JLRTB02052NAS4

# TECHNICAL BULLETIN

## SUBJECT /CONCERN:

Rear Doors Difficult To Open

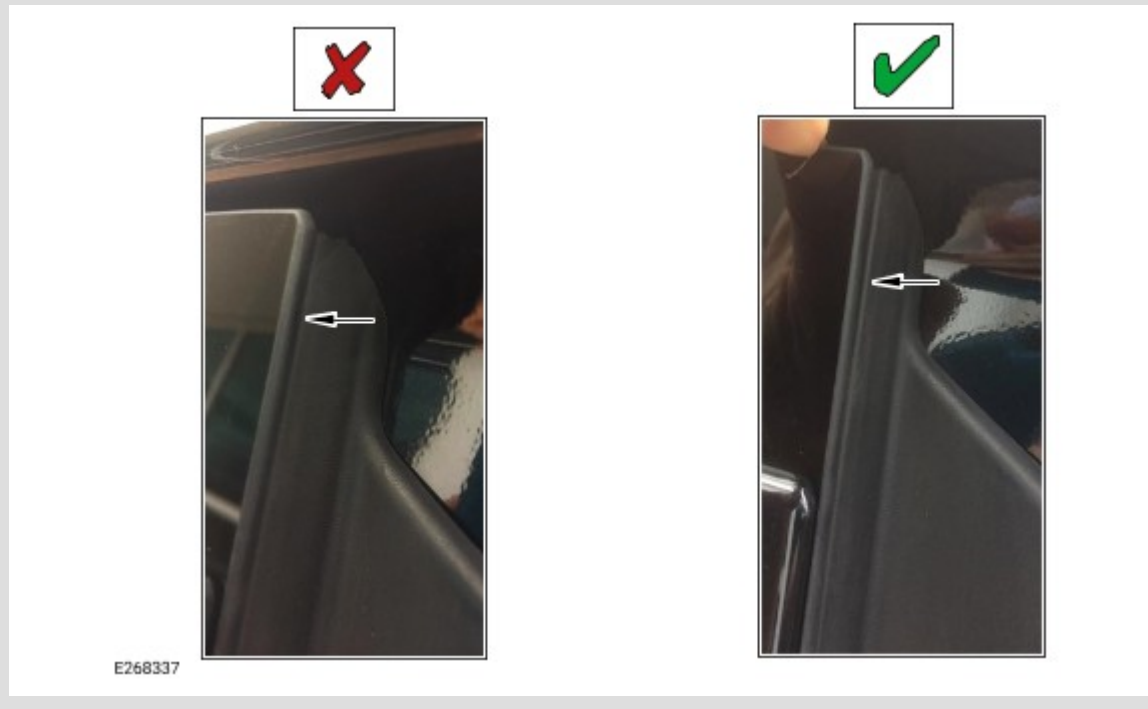
If the door seal is catching on the exterior trim panel, proceed to **Service Instruction A**.

If the margin seal is catching on the C-Pillar glass, complete **Service Instruction C**.

If the C-Pillar exterior trim is incorrectly installed, complete **Service Instruction C**.

## SERVICE INSTRUCTION A - DOOR ALIGNMENT

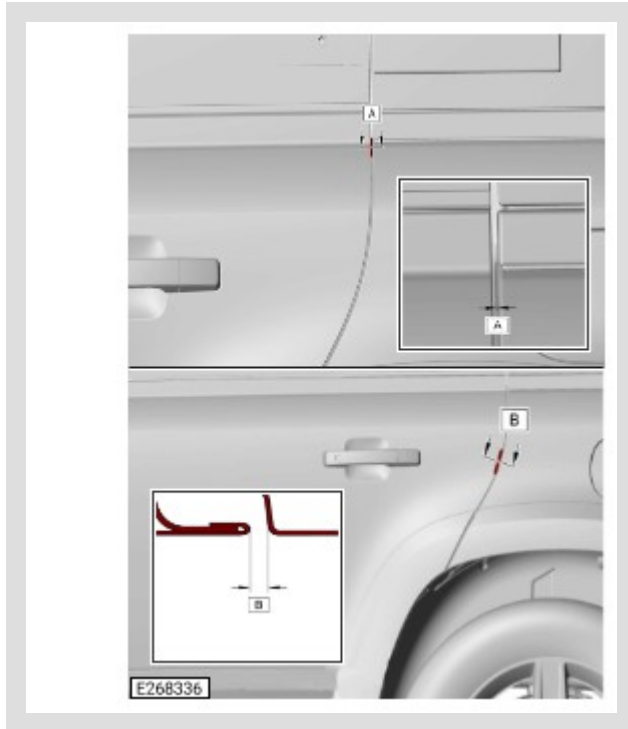
Check the alignment of the rear door(s) in the areas shown in the illustration.

SECTION	DESCRIPTION	GAP	PROFILE
A	Rear door to rear quarter	N/A	0.0 ± 0.5 mm
B	Rear door to rear quarter	3.5 ± 0.7 mm	0.0 ± 0.7 mm

Only adjust the rear doors that are either out of alignment tolerance or do not have a gap of 2.8 mm.

Adjust the rear door(s) to be as far rearward as possible while still being within tolerance, the gap must be 2.8 mm (see TOPIx Workshop Manual section 501-26: Body Repairs: Vehicle Specific Information and Tolerance Checks - General Procedures - Rear Door Alignment).

#### **SERVICE INSTRUCTION B - DOOR SEAL MODIFICATION**

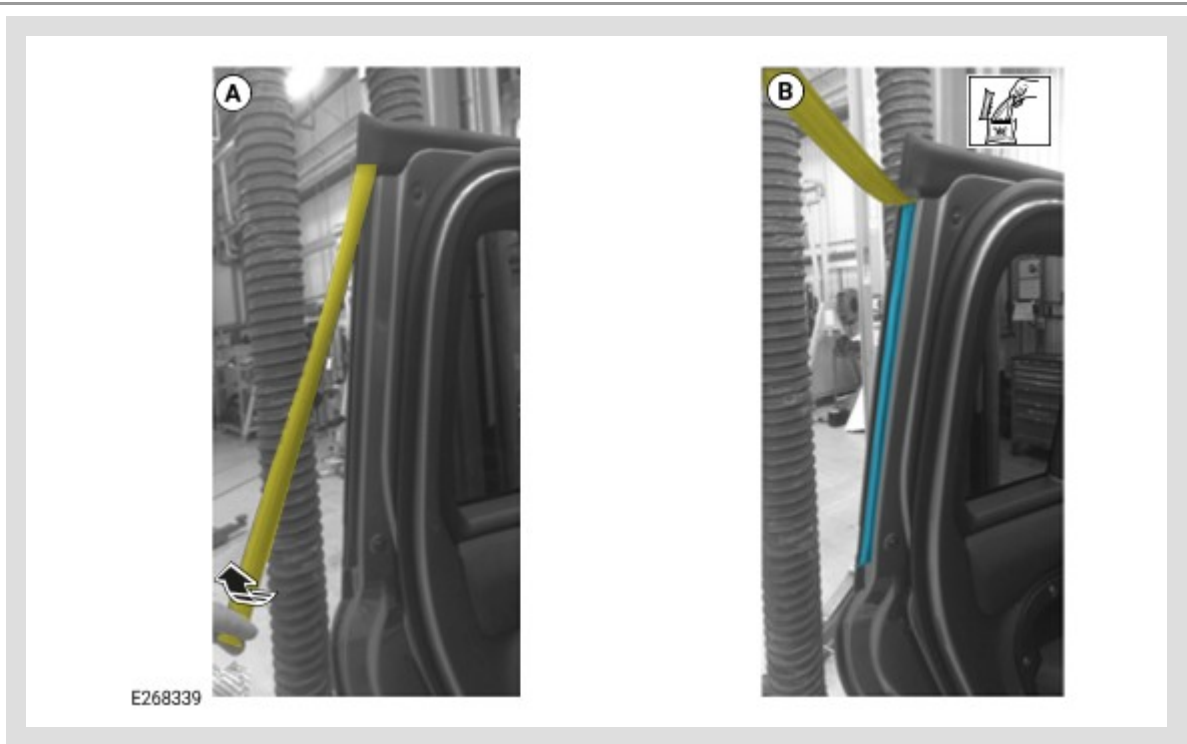
**(A)** Reposition the section of rear door seal shown in the illustration.

**(B)** Make sure the area highlighted in the illustration is clean, dry and free from contamination.

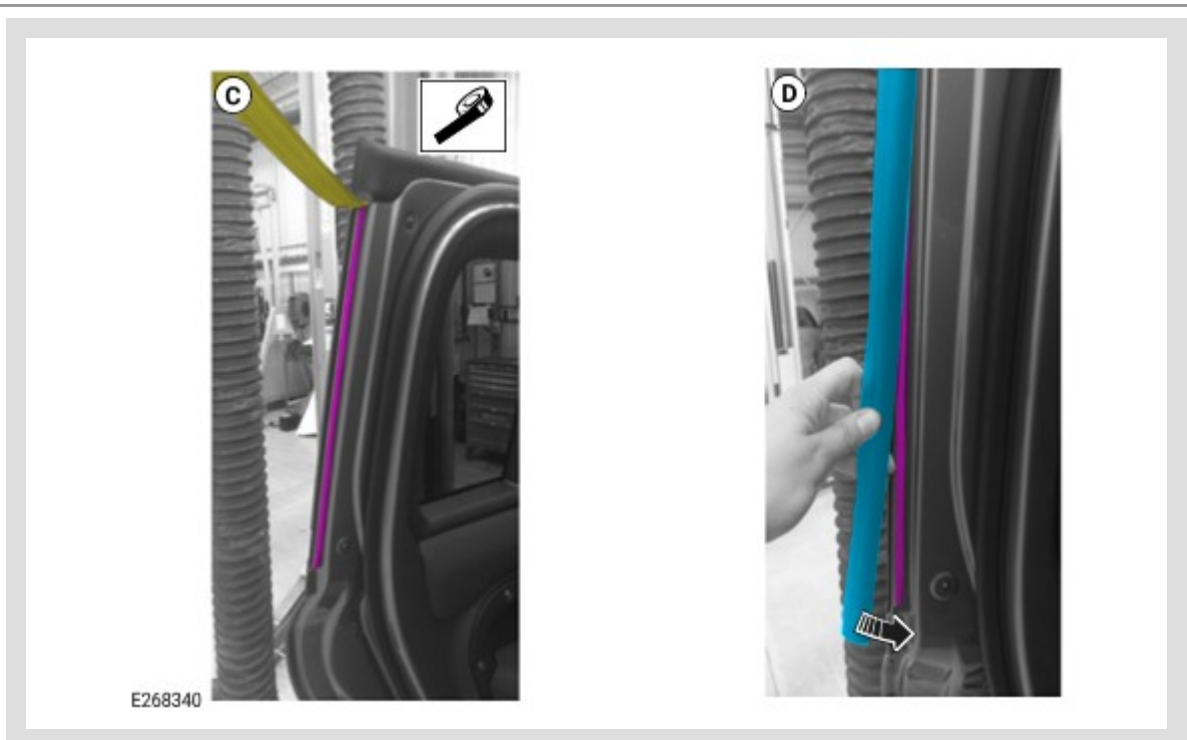
**(C)** Apply the double sided adhesive tape along the seal path on the door frame, as shown in illustration 'C'. Do not remove the protective backing from the double sided adhesive tape at this stage.

**(D)** Install the section of rear door seal removed during step 2.

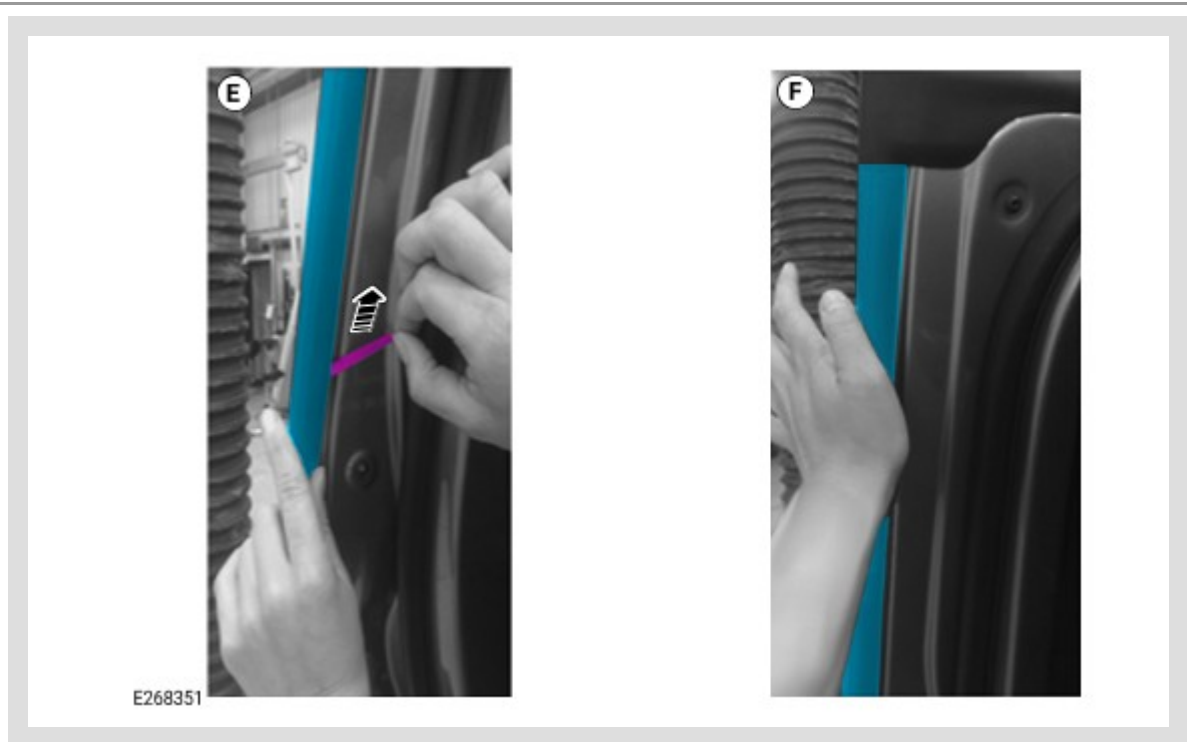
(E) With the rear door seal installed, remove the protective backing from the double sided adhesive tape.

(F) Apply firm pressure to the rear door seal to make sure it is adhered to the double sided adhesive tape.

#### SERVICE INSTRUCTION C - RENEW C-PILLAR EXTERIOR FINISHER TRIM

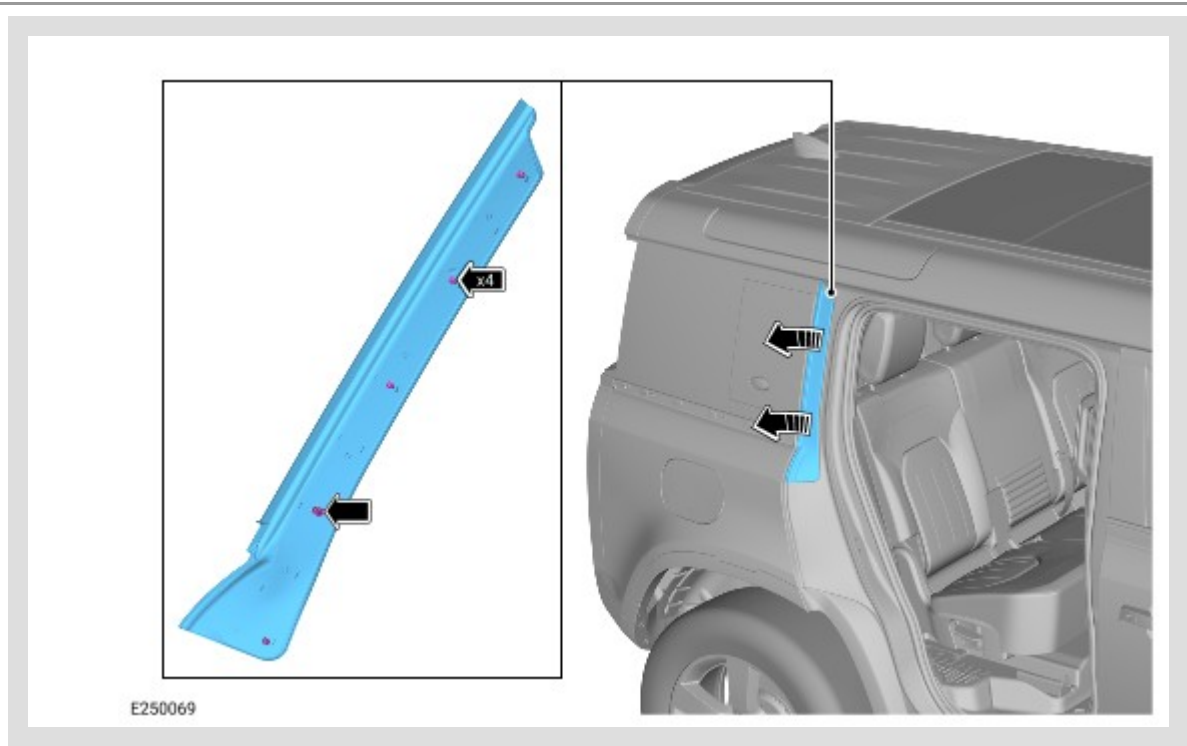
Remove and discard the C-pillar exterior finisher trim.

- Clean the area behind the C-pillar exterior finisher trim.

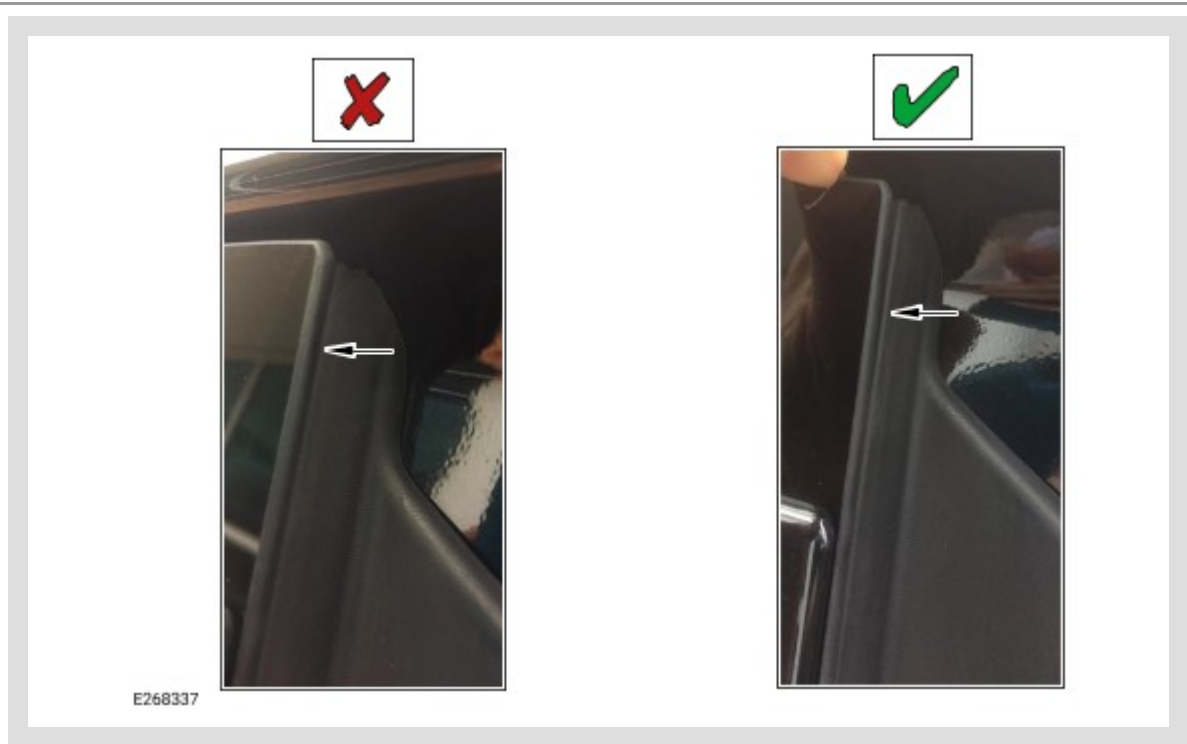
The image with the **RED 'X'** shows the C-pillar exterior finisher trim installed incorrectly behind the rear quarter window.

The image with the **GREEN "** shows the C-pillar exterior finisher trim installed correctly with a 1-1.5 mm protrusion from the rear quarter window.

Install the new C-pillar exterior finisher trim.

- Remove the adhesive tape backing.
- **Make sure the C-pillar exterior finisher trim protrudes 1-1.5 mm away from the rear quarter window, as shown in the illustration, before fully securing.**
